INDEX OF SHEETS		SHEET No.
TS01	TITLE SHEET	01
GN01	OVERALL SHEET KEY	02
GN02	GENERAL NOTES	03
RD01-RD07	ROADWAY PLAN & PROFILE	04-10
SDGN01	STORM DRAIN SHEET KEY	11
SDGN02	STORM DRAIN GENERAL NOTES & DETAILS	12
SD01-SD05	STORM DRAIN PLAN & PROFILE	13-17
DFGN01	DETENTION POND GENERAL NOTES	18
DF01-DF04	DETENTION POND 1 SITE PLAN	19-22
WT01	WATER CISTERN PLAN & DETAILS	24

HAY CREEK VALLEY

CONSTRUCTION DOCUMENTS

SEPTEMBER 2023

DETENTION POND PLAN
H: 1"=40'

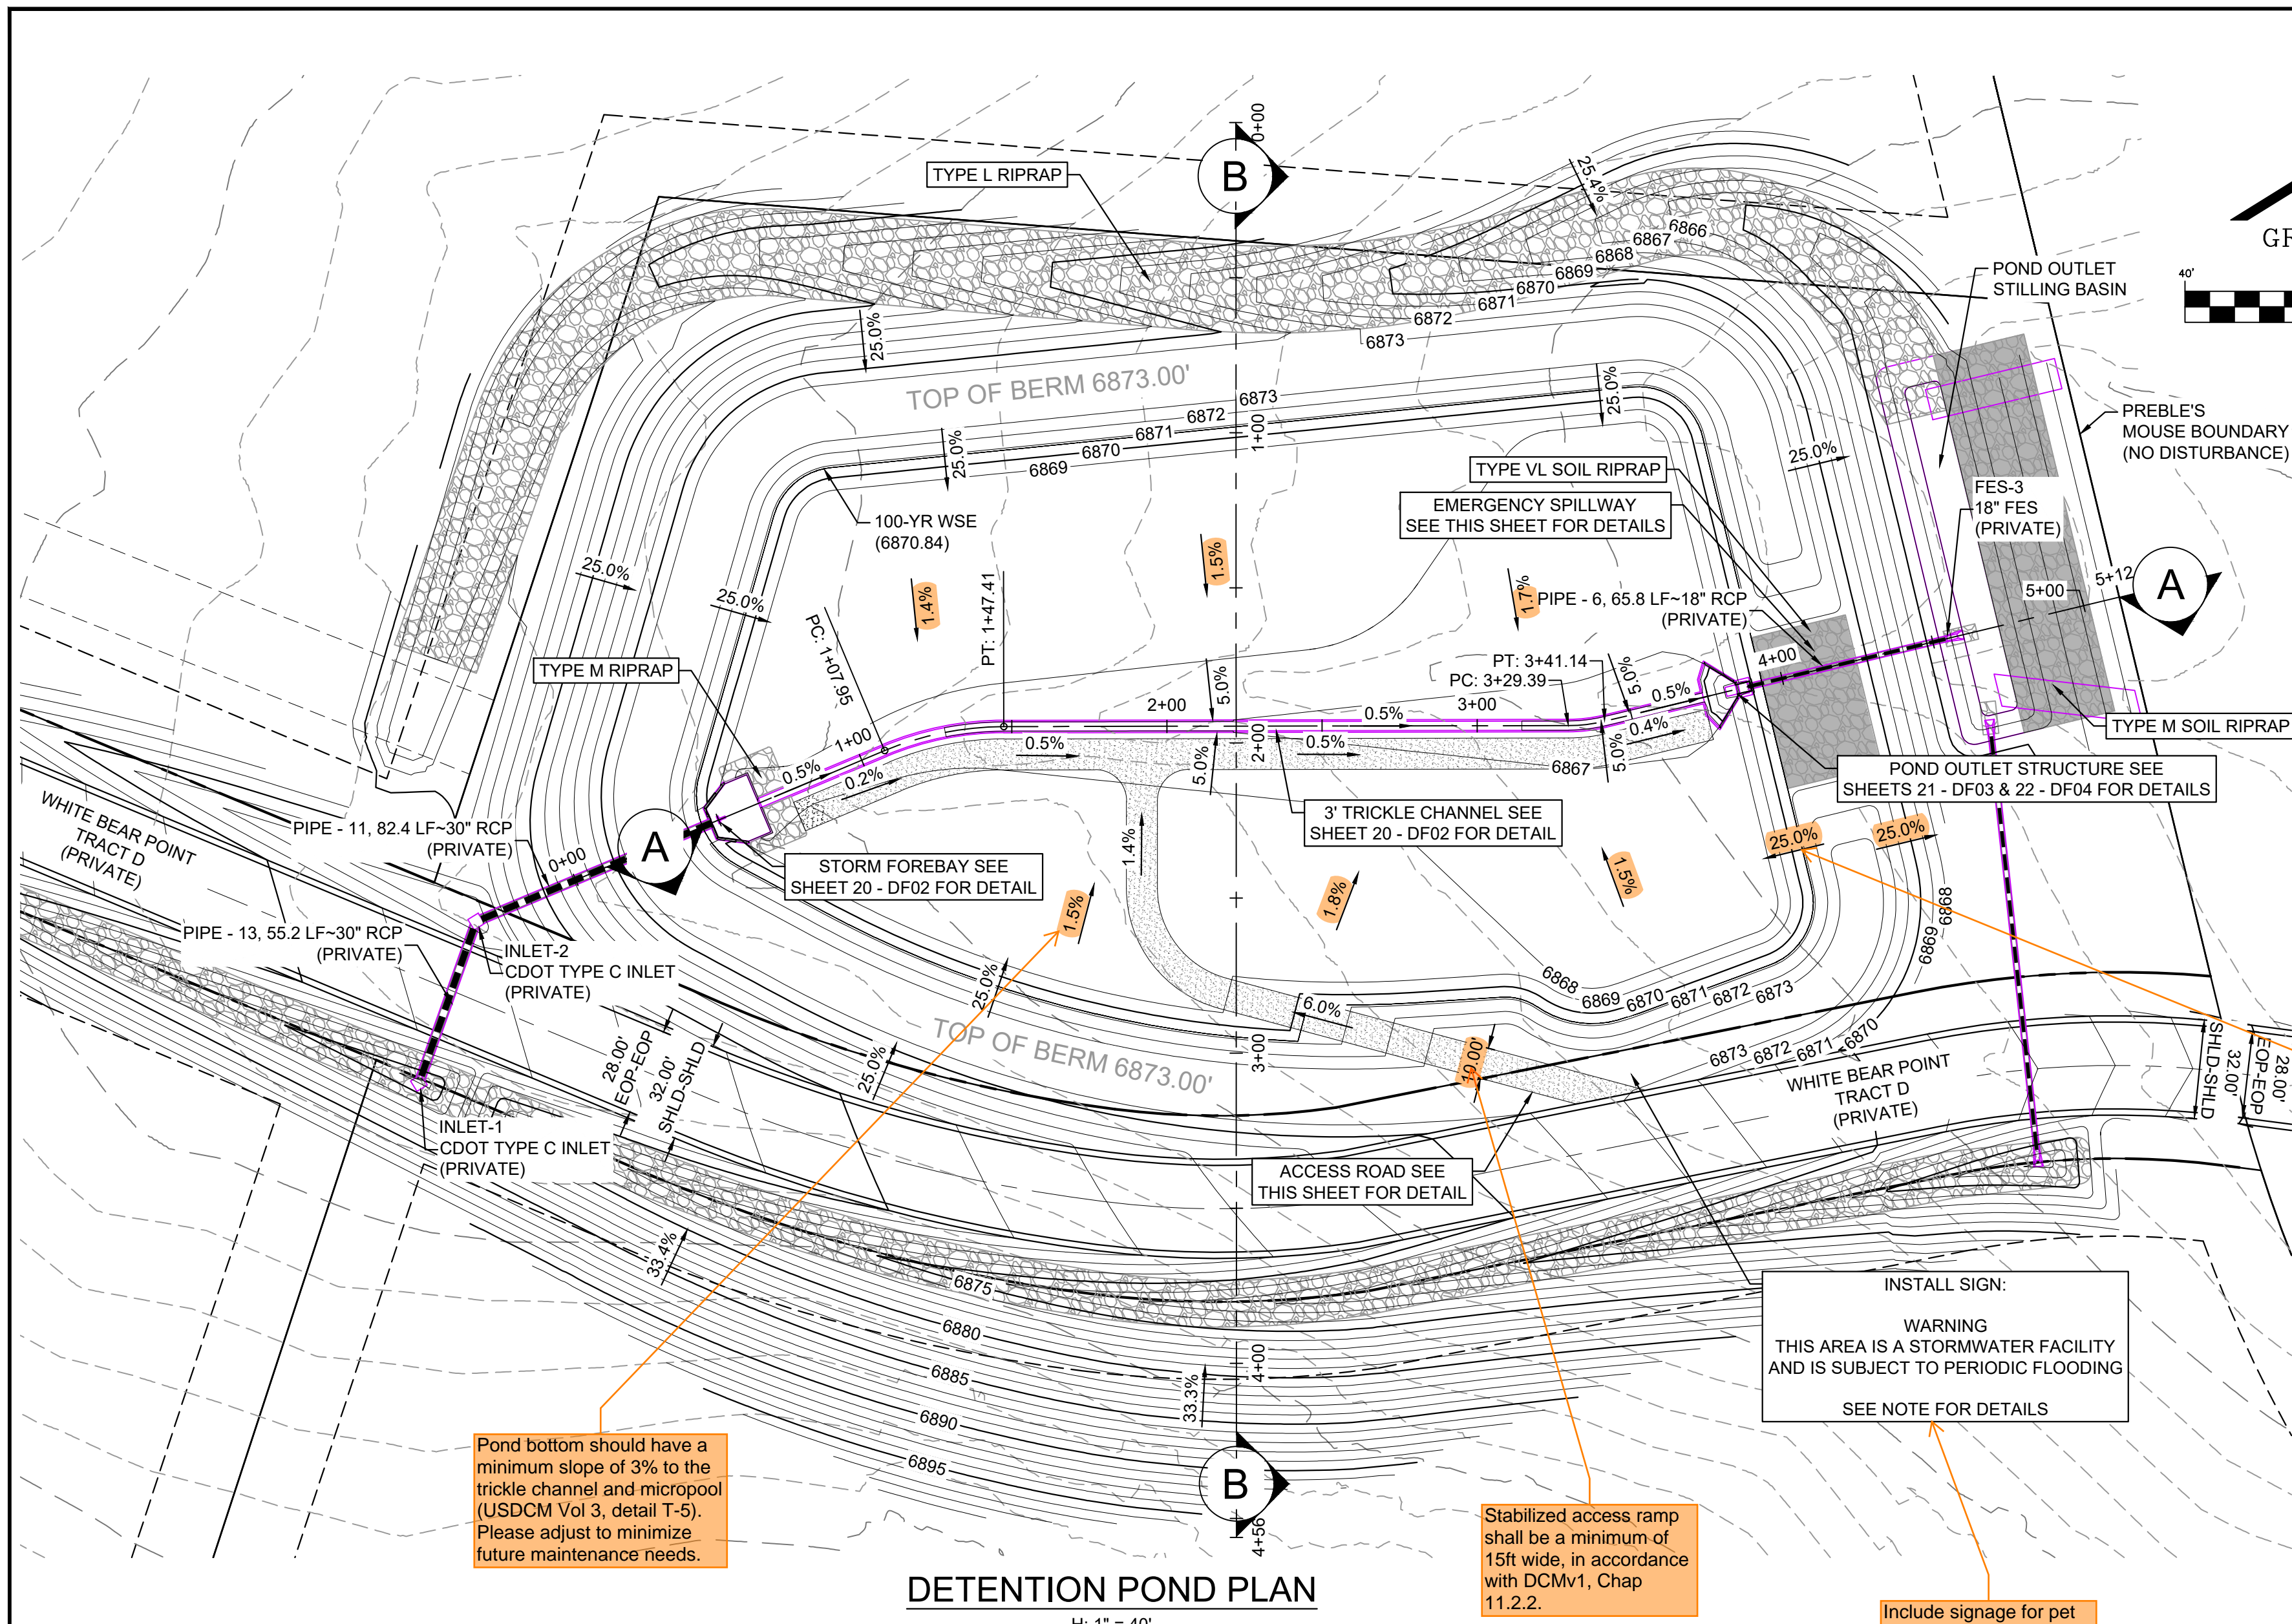
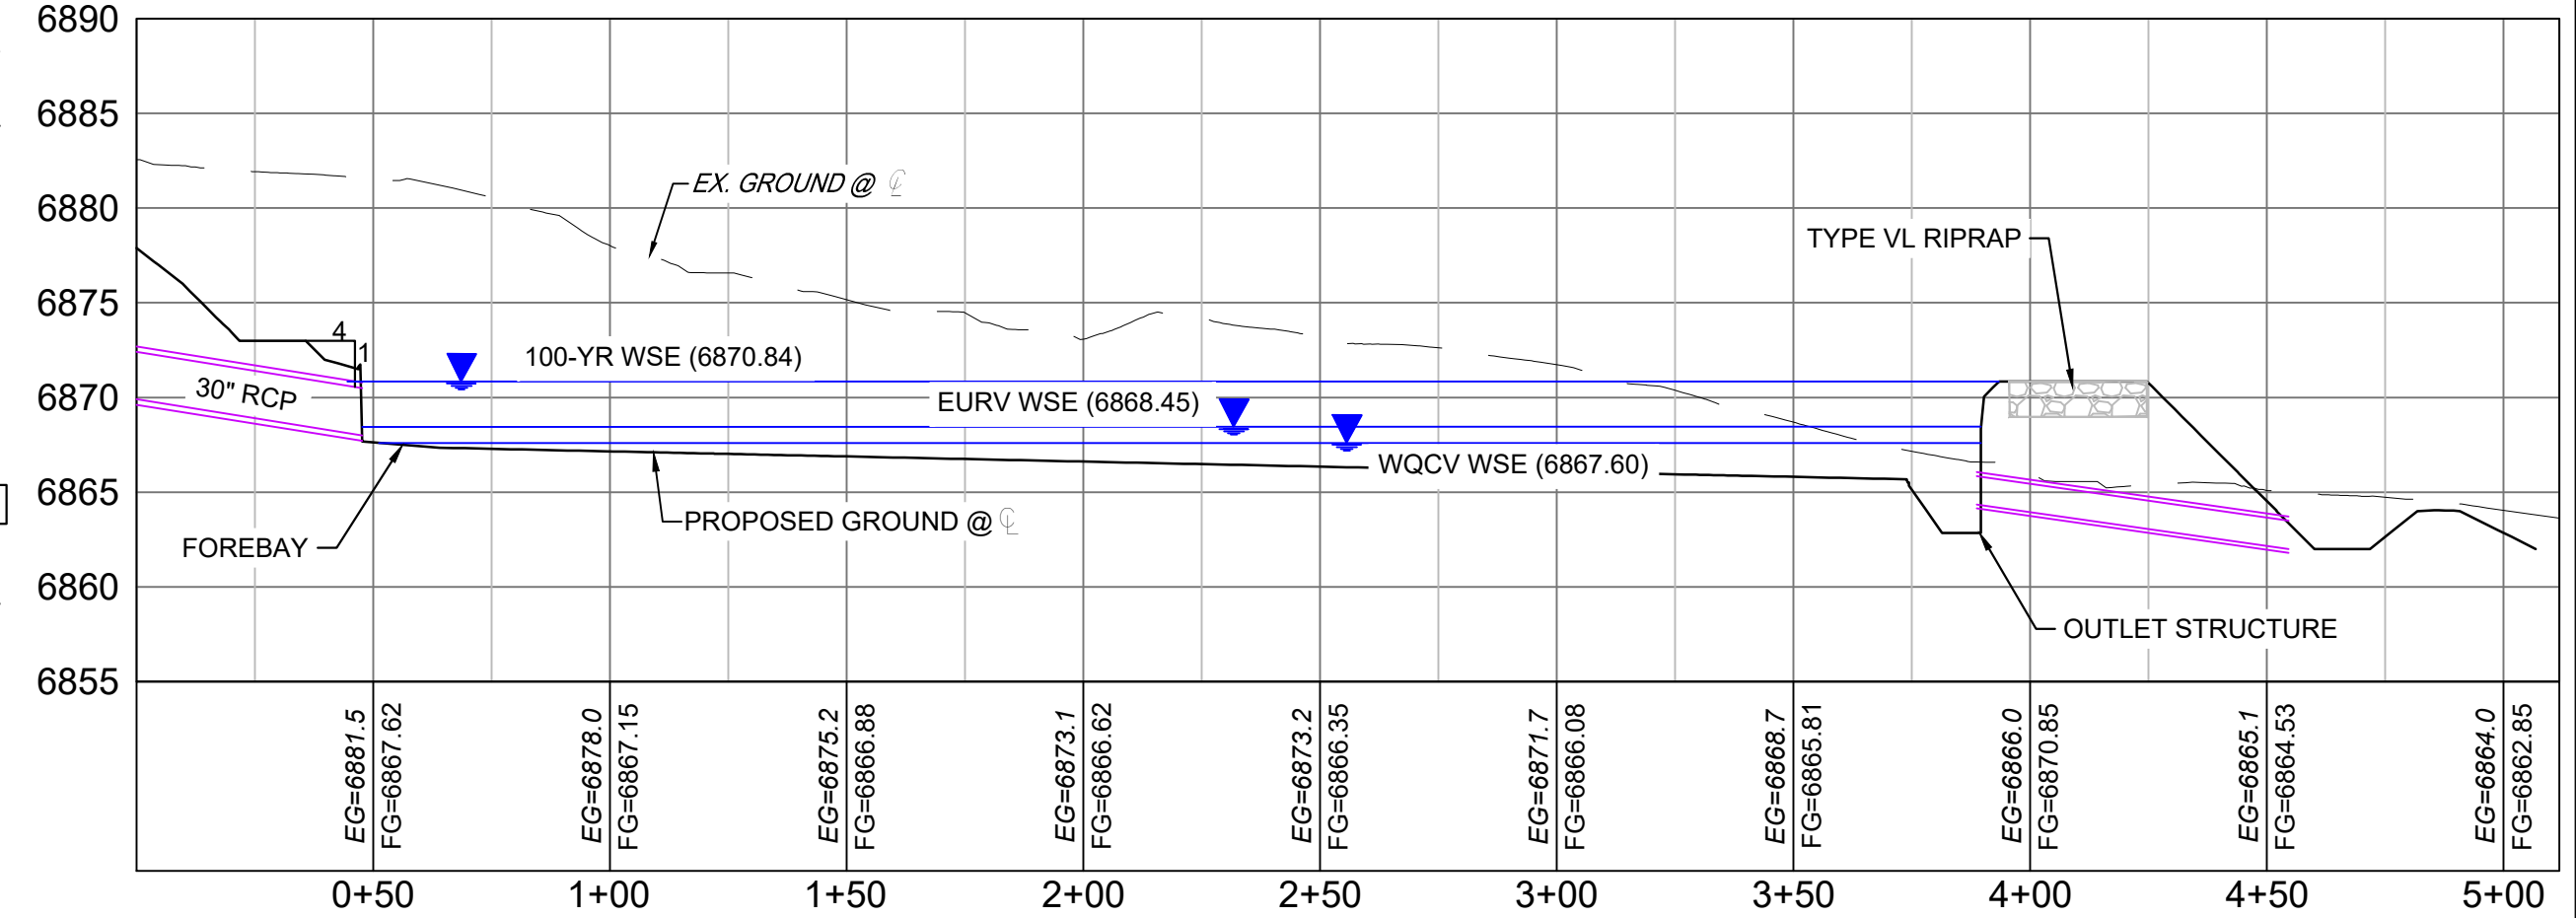
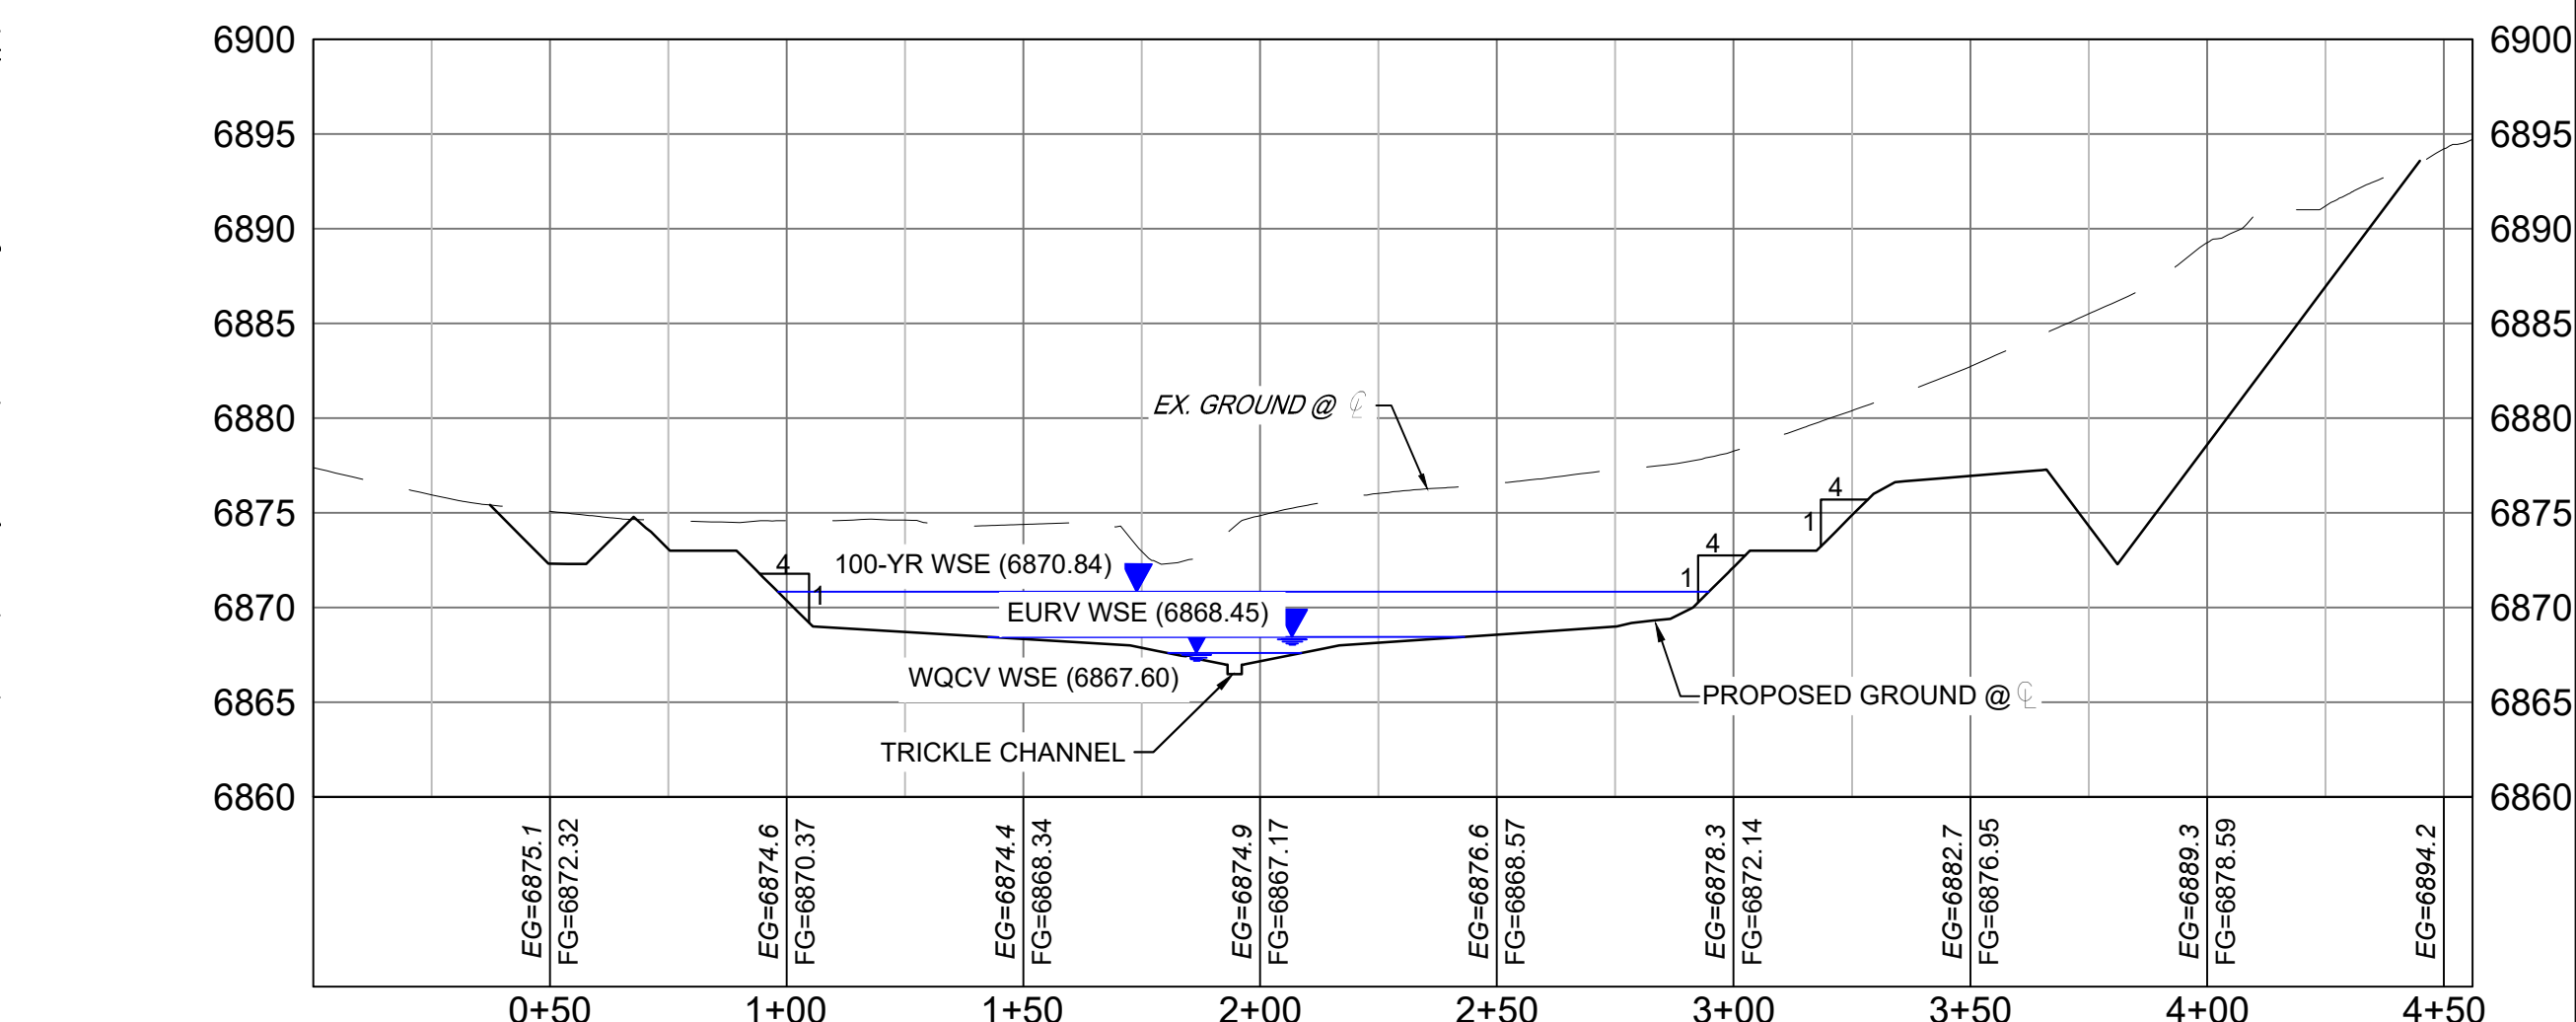
Soils Report states that ponds shall have 5:1 slopes. Update to match the geotech recommendations.

Pond bottom should have a minimum slope of 3% to the trickle channel and micropool (USDCM Vol 3, detail T-5). Please adjust to minimize future maintenance needs.

Stabilized access ramp shall be a minimum of 15ft wide, in accordance with DCMv1, Chap 11.2.2.

Include signage for pet waste station(s) around the pond, with text stating that pet waste must be picked up.
